Job Name: The Old Power Station Vastern Road
Job No: 47500
Note No: TN006
Date: 24th September 2020
Prepared By: Joe House
Subject: RBC Highway 3rd Response & Vastern Road Crossing

This technical note has been prepared by Stantec on behalf of Berkeley Homes (Oxford and Chiltern) Ltd to provide a response to Reading Borough Council (RBC) highway comments provided in an email from Darren Cook to Jonathan Markwell dated 15th September 2020.

The current carry distances from the bin stores to the collection points are as follows based on the refuse access strategy shown on 47500/5500/005A.

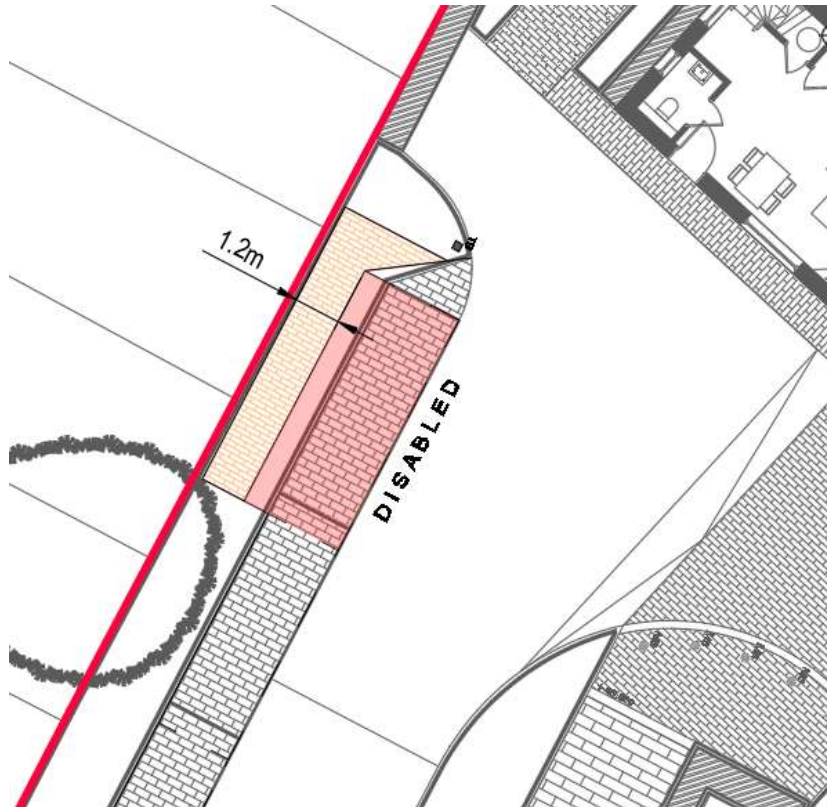
The submitted information address the concerns regarding Bin store No. 4 but as per previous comments, other bin stores were located in excess of 10m which is the design recommendation and the distance to which RBC refuse collection team work to. It would therefore need to be confirmed what arrangements will be put in place for all refuse stores that exceed the distance to ensure that bins are not left obstructing the surrounding footways.'

It is noted that RBC states that the 10m distance is a design recommendation, rather than a fixed standard or requirement.

Bin Store 1 (Building EFG) – 11m
Bin Store 2 (Building D) – 3m
Bin Store 3 (Building C) – 7m
Bin Store 4 (Building B, north) – 10m
Bin Store 5 (Building B, south) – 11m
Bin Store 6 (Building A) – 10m

As summarised above, the distance to the bin stores at building EFG and B (south) are only 1m over the recommended distances for operatives. Given that this is only a minor and likely un-noticeable distance in reality, we do not believe it is necessary to alter the collection arrangements.
